1 Products affected

Product hierarchy no.				Part no.	SBU	Product Type	Customer part no.
SBU	PG	PUG	Type				
01	002	002	0000000502	See table below	Circuit Protection	FPG3 fuse holder	-

3 Detailed description of change

Current Packaging Label	New Packaging Label

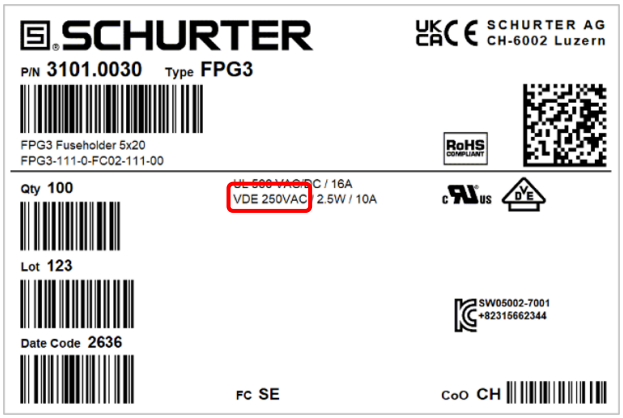
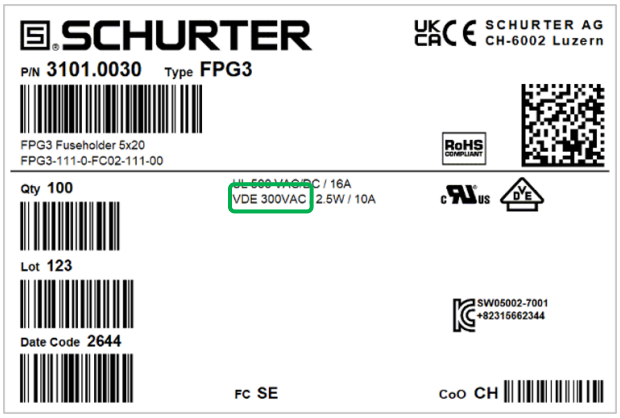
The voltage rating changes from VDE 250VAC to 300VAC

☒	Form	No action required; inform incoming inspection about changes on product marking
☐	Fit	
☐	Function	
☐	Manufacturing	
☒	Label	No action required; inform incoming inspection about changes on packaging label
☐	Packaging
